**RE: Urban Village Development Commission Meeting**

The Urban Village Development Commission (UVDC) will be meeting at **7:00 pm, Tuesday, March 19<sup>th</sup>, in the Council Chambers, located at 135 E. Sunset Way** for a Public Briefing on the Ichijo Preliminary Plat, Issaquah Highlands Parcel 2.

**Staff Contact:** Peter Rosen, Environmental Planner  
Development Services Department, (425)-837-3094

**Request:** Application for approval of a preliminary plat for Parcel 2 of the WSDOT TDR; creating 36 single-family residential lots, roadways, utilities and a recreation tract on 4.28 total acres.

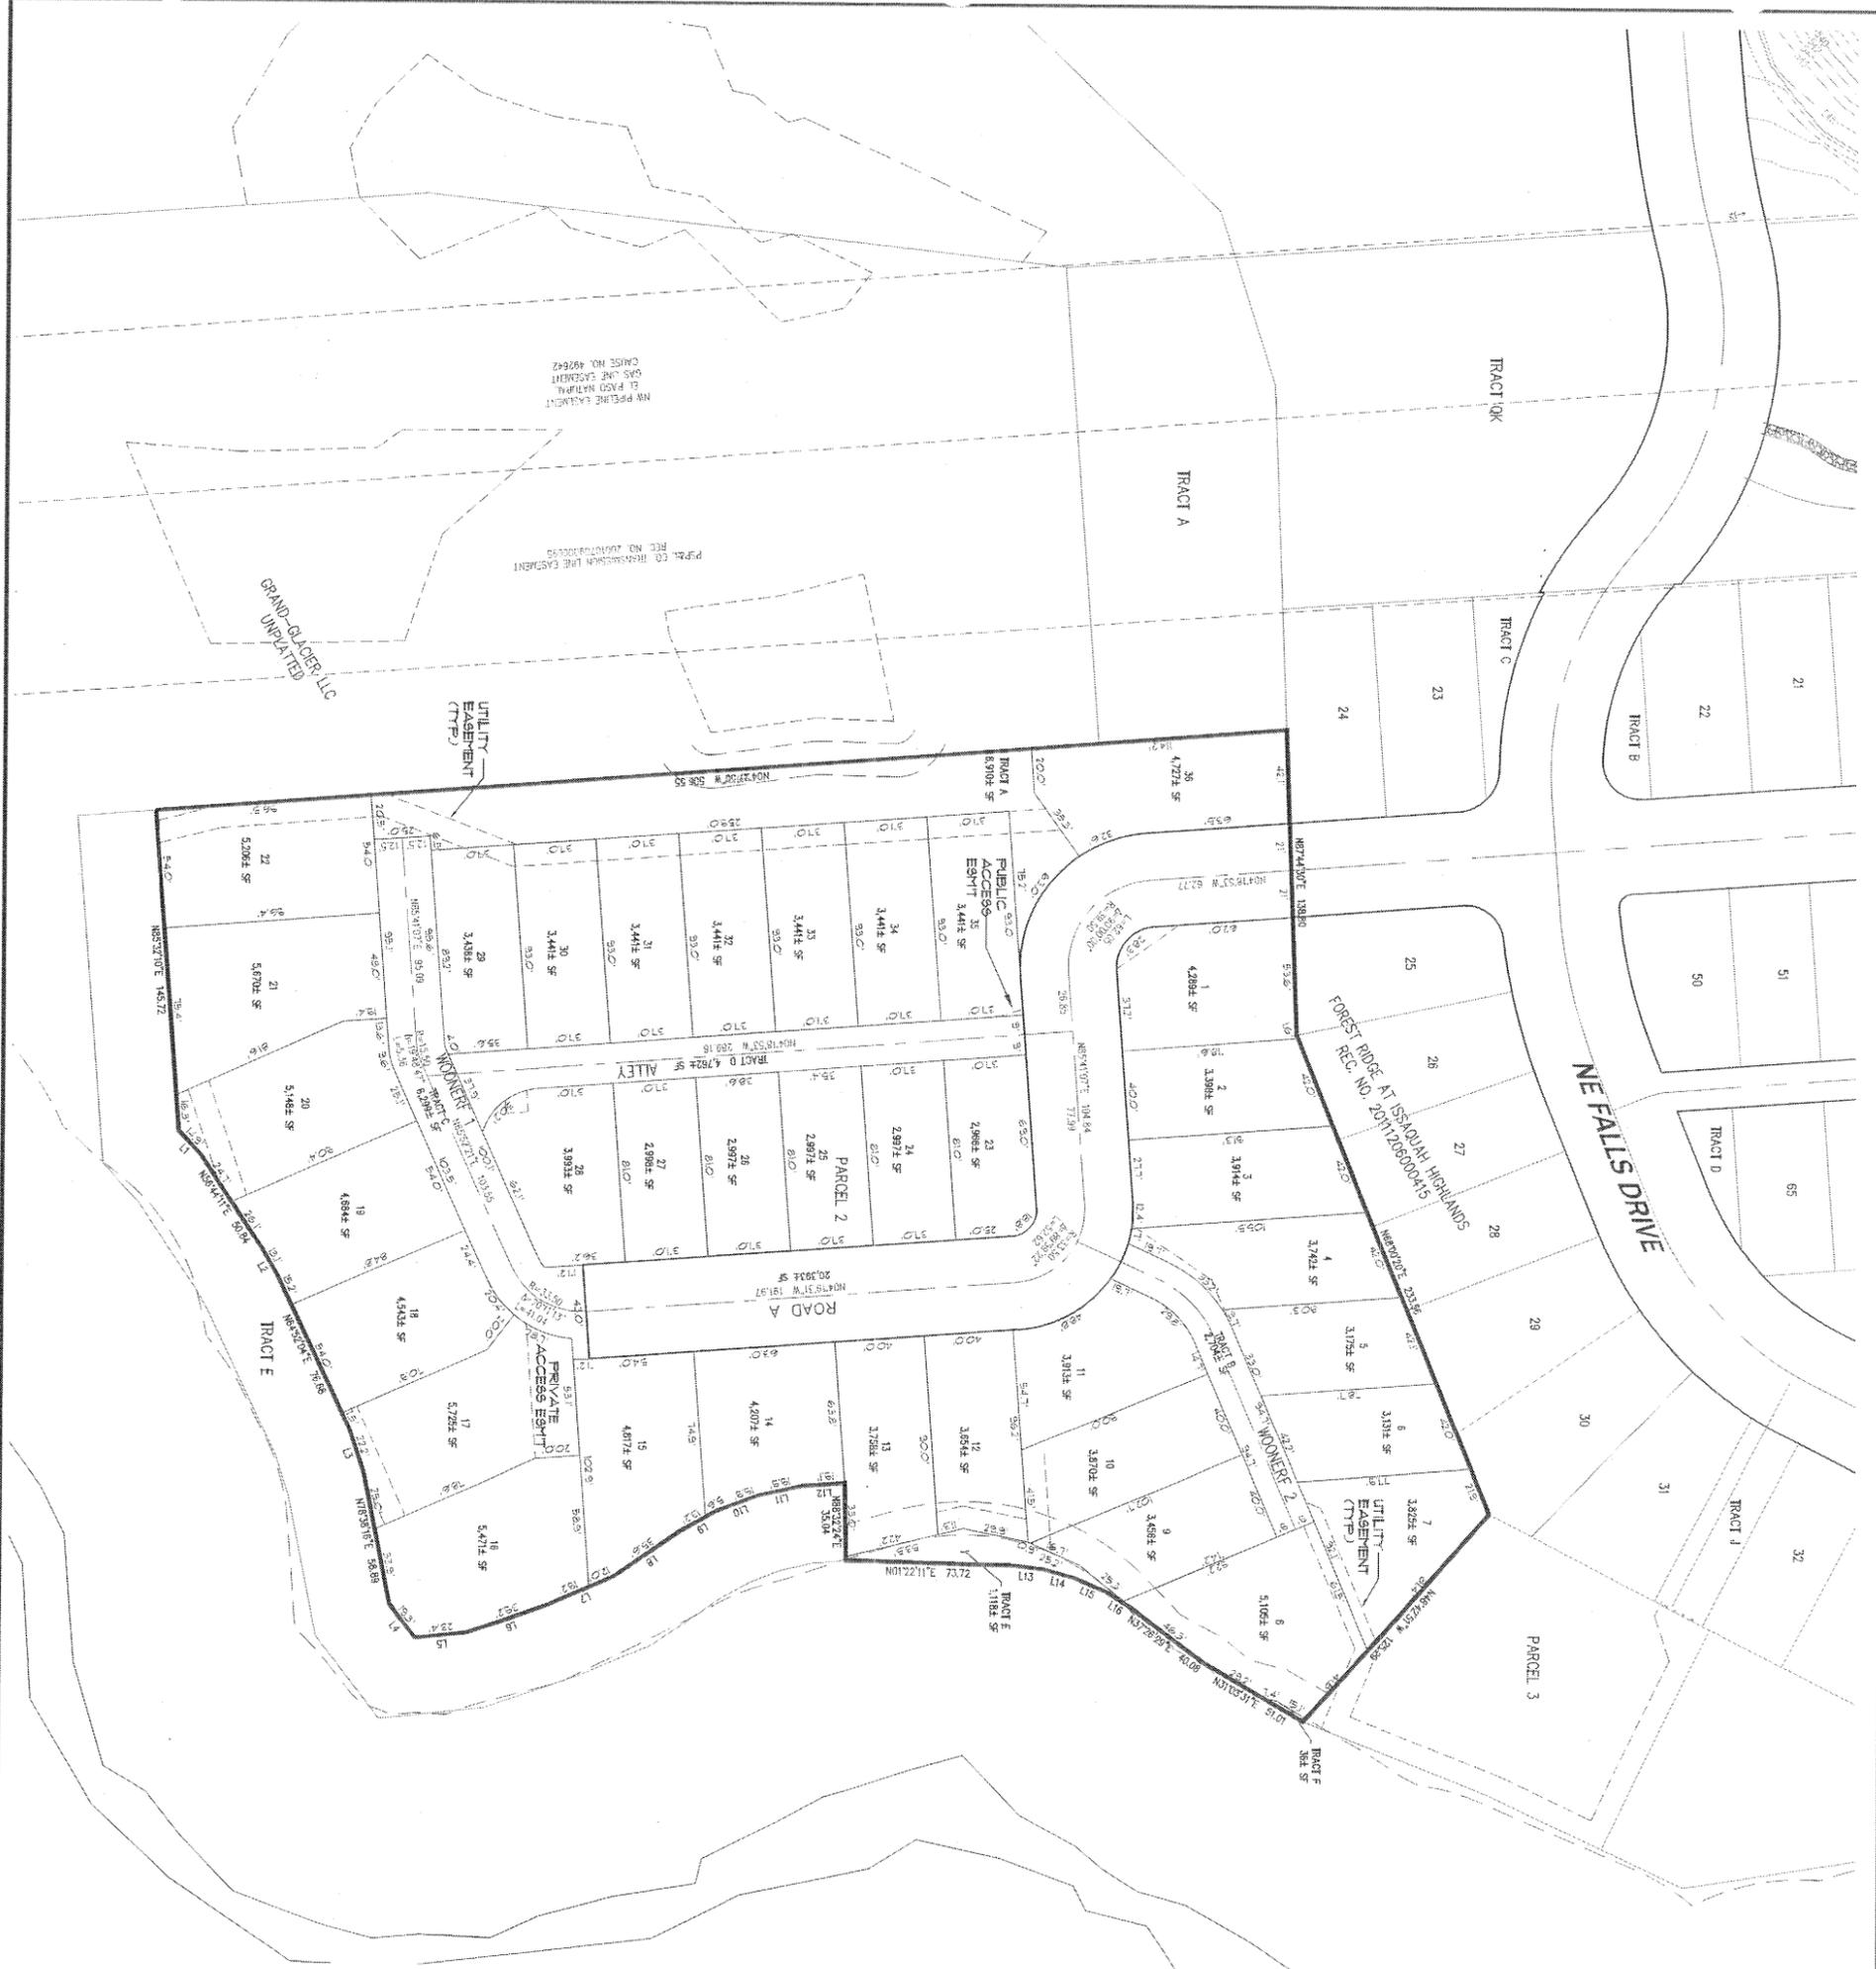
Natural grades are to be preserved to the extent possible and fills may not exceed 12 feet from the pre-development grade (Section 6.2). Per the Preliminary Grading Plan (Sheet PO5), fill along the south boundaries of Lots 18-20 may exceed 12 feet, which with permits for grading be reviewed for compliance.

Sheet P06 shows a stormwater pipeline on Lot 22 that connects portions of the site to the Parcel 2 Tightline. This pipeline is shown within a 10' easement. The easement is too narrow to meet City standards and must be increased to a minimum of 15' wide or the pipeline must be designed in a manner that mitigates the narrow access corridor and limited work area. [Condition 30]

**[Condition 19]** Fill shall not exceed 12 feet from the normalized pre-development grade. This shall be verified particularly for the proposed fill along the south boundaries of Lots 18-20. This is required prior to approval of grading plans.
